ADA Self-Evaluation and Transition Plan Update

Midpeninsula Regional Open Space District

Appendix B

ADA Facility Assessment Reports

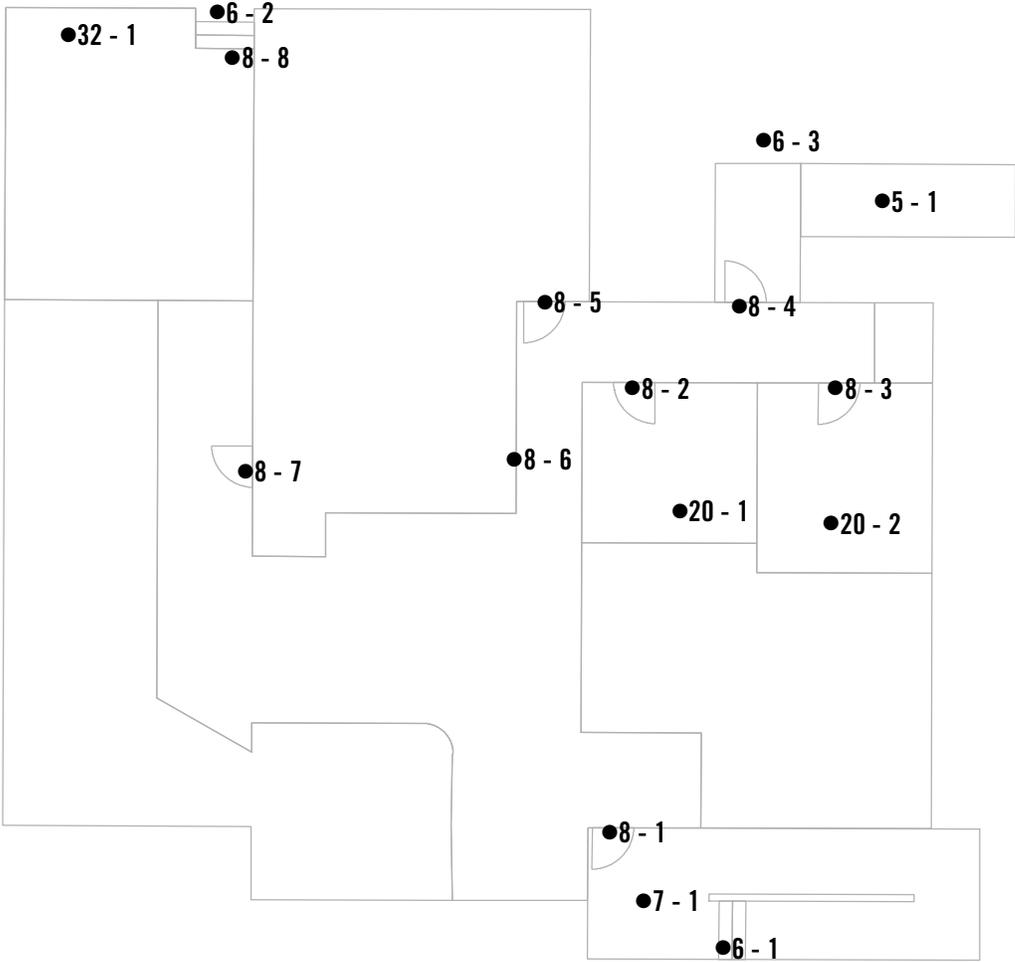
Notes: Drain ruts create opening 8" to 10" wide (1/2" max).
